Your ref: 24/2179/VRC

Written Representations: Objection to variation to planning approval 24/2179/VRC (the “Application” or the “VRC”) in respect of 116A Amyand Park Road, Twickenham TW1 3HP (the “Development”)

Image 1 – First Floor plan in 21/3806/FUL

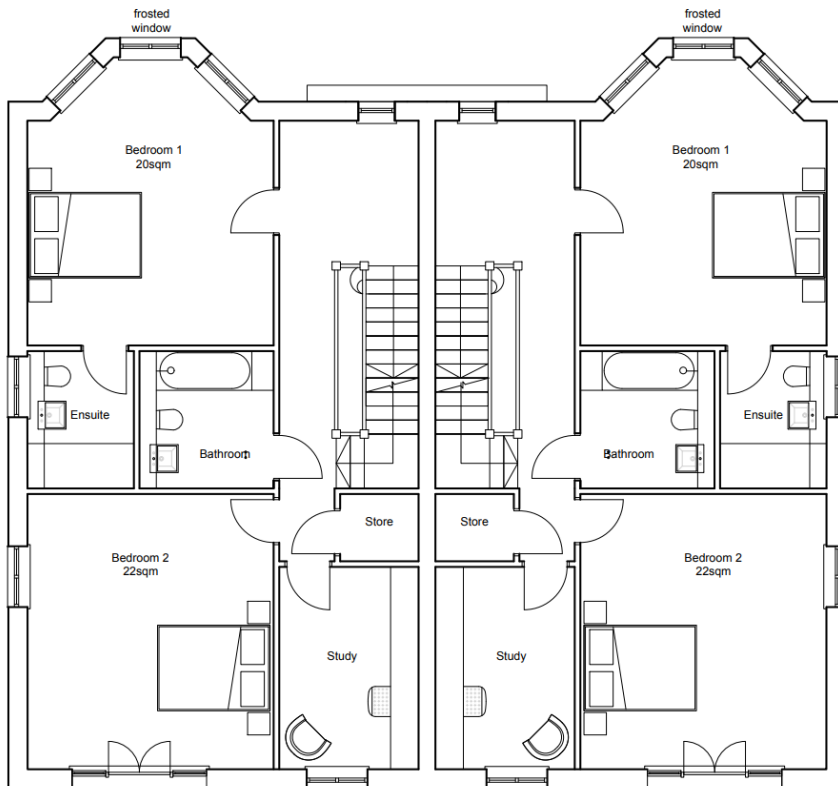
2.3 As noted in paragraph 2.1 above the planning history of the Development is instructive. The layout proposed in 21/3806/FUL included bedrooms at the front of the proposed houses on both the first and second floors as shown in Images 1 and 2 below.

- 2.4 This was refused by the Council including the rationale that *“It would not be appropriate to condition for obscure glazing and non-opening of all first floor bay windows and front elevation dormer windows as this would detrimentally impact on living conditions for future occupiers given these are primary and sole windows to habitable rooms.”*

- 2.5 On appeal the Planning Inspectorate agreed with this conclusion, stating *“it is noted that the accommodation at second floor level is annotated on plans as being for bedroom/study, the plans depict beds located within those rooms. In that respect and in terms of the effect on the living conditions of future residents of the scheme with regards to outlook, it would not be suitable to include obscured glazing for those habitable rooms”.*

Image 3 – First Floor plan in 22/1711/FUL

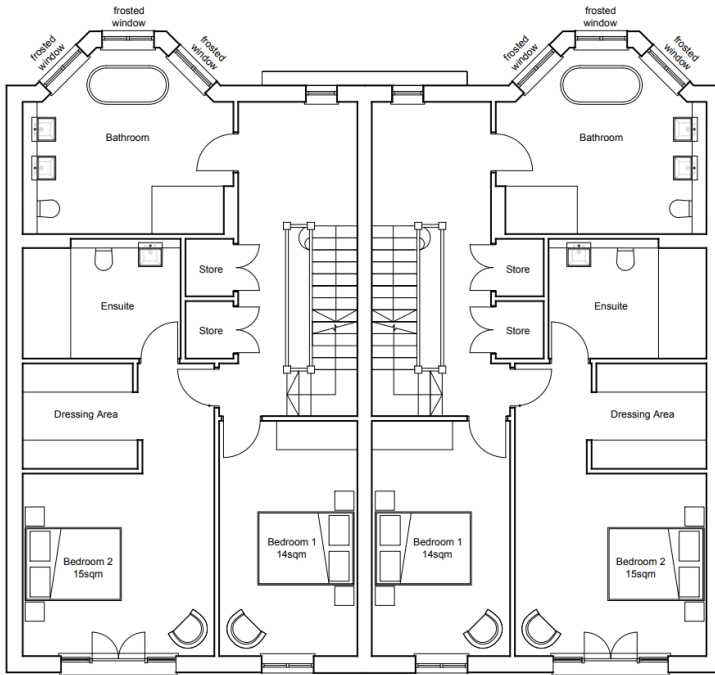
- 2.6 This created clear history that habitable rooms in the Development, consistent with planning law, could not have obscure glazing and unopenable windows. No doubt taking this on board, the plans approved in 22/1711/FUL replaced the bedrooms on the first and second floors overlooking 112-116 Amyand Park Road with bathrooms as shown in Images 3 and 4 below.

- 2.7 Taking the application at face value, it mitigated the reasons for rejection of 21/3806/FUL. However this layout was never credible, particularly on the first floor where the smallest bedroom (labelled Bedroom 1) benefited from by far the largest bathroom. Indeed, this point was made in my objection at the time where I stated “*The Application has been amended from the Previous Applications with frosted windows overlooking the Property with the rooms changed to bathrooms. I contend that the plans show a poor use of space and it is highly likely that the Applicant would seek to change the rooms use and glazing during construction.*”

Image 5 – First Floor plan in VRC/3806/FUL

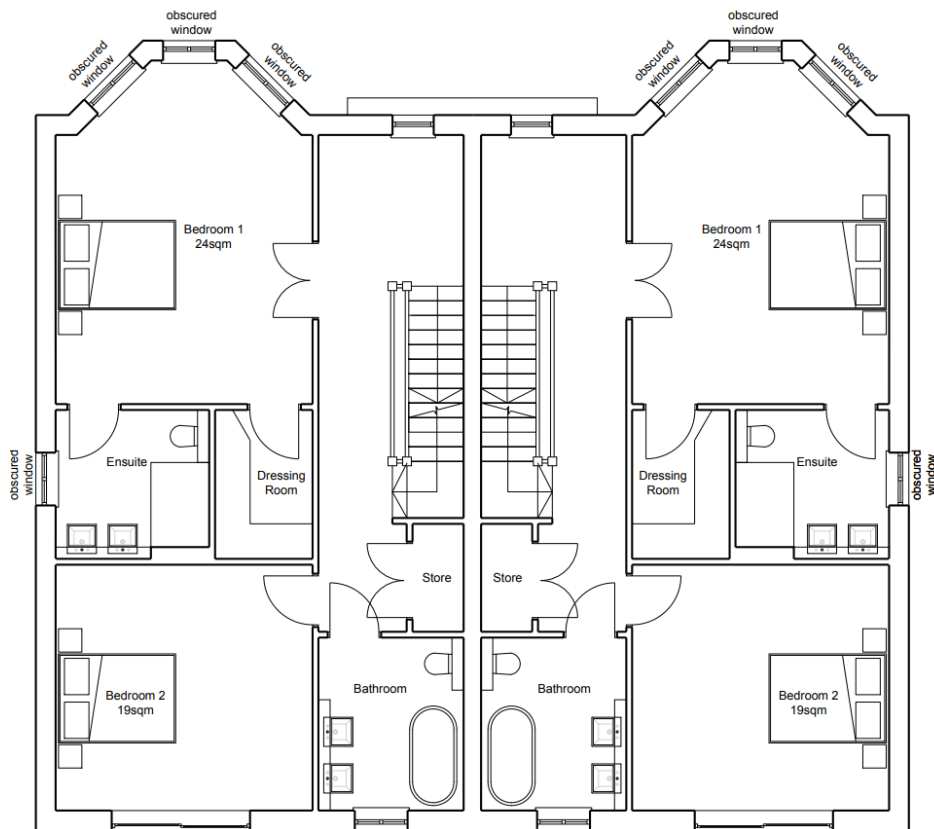
- 2.9 The Development as built bears no resemblance to that approved in 22/1711/FUL. The layout of the first floor included in the VRC, and as built, as shown below has a bedroom on the first floor overlooking 112-116 Amyand Park Road only benefiting from windows with obscure glazing and supposedly non openable (see para 2.10 below). In all practical sense the layout and provision is equivalent to that already rejected in 21/3806/FUL with the only real change being the study being replaced with a bathroom serving bedroom 2 as can be seen in Image 5 below.

- 2.10 A bedroom which only benefits from windows with obscure glazing and not openable very clearly contravenes the findings of both the Council and Planning Inspectorate in relation to 21/3806/FUL as it materially impacts on living standards for future occupiers given these are primary and sole windows to habitable rooms. **The VRC must therefore be rejected.**

Image 6 – Second Floor plan in VRC/3806/FUL

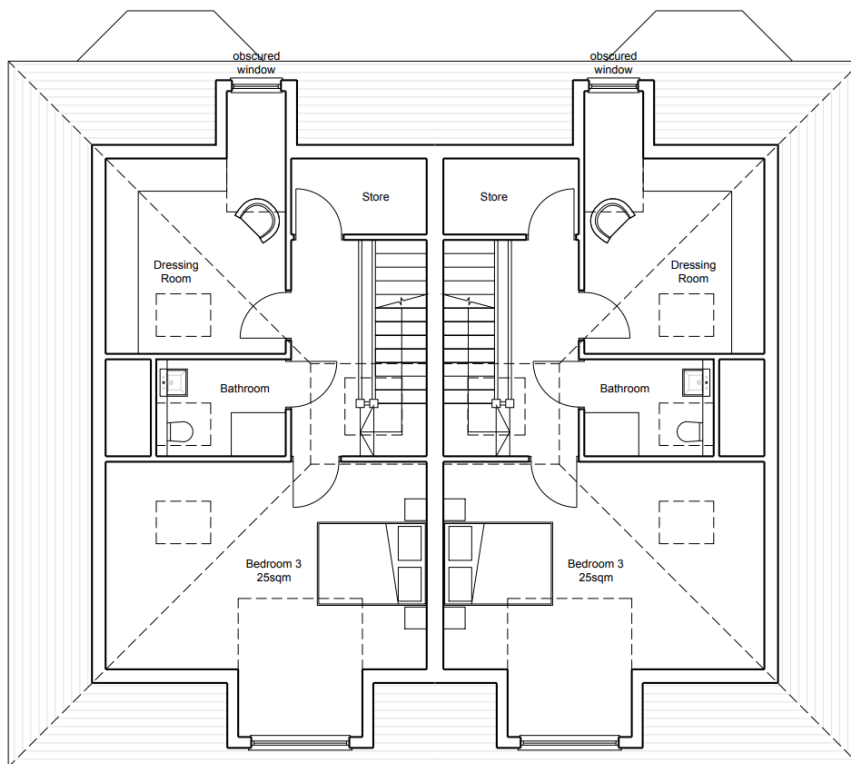
- 2.11 Turning to the second floor the plans in the VRC are deliberately misleading. The room at the front overlooking 112-116 Amyand Park Road is clearly intended to be a 4th bedroom rather than a dressing room. As seen above in para 2.7 relating to 22/1711/FUL it makes no sense for a dressing room to a large bedroom to be down a corridor. It is instructive to see that the layout, as shown in Image 6 below, is essentially identical to that rejected in 21/3806/FUL shown in Image 2. The only change is removing the drawing of a bed and changing the name, there is no change in layout or provision at all. The Applicant is treating the process as a joke and given the changes noted on the first floor it is simply not credible to believe this is not intended to be a 4th bedroom. It is the only way the layout makes sense.

- 2.12 This creates the same problem as on the first floor described in paras 2.4-2.10 above in that a habitable room only benefits from an obscure glazed window. As described in paragraph 2.10 above this contravenes the findings of both the Council and Planning Inspectorate in relation to 21/3806/FUL as it materially impacts on living conditions for future occupiers given these are primary windows to habitable rooms. I note roof light has been added to the room which was not approved in 22/1711/FUL. As addressed in paras 3.11-3.13 for this to be approved it must also be obscured glazed and therefore does not provide any mitigation. As such, **the VRC must therefore be rejected.**
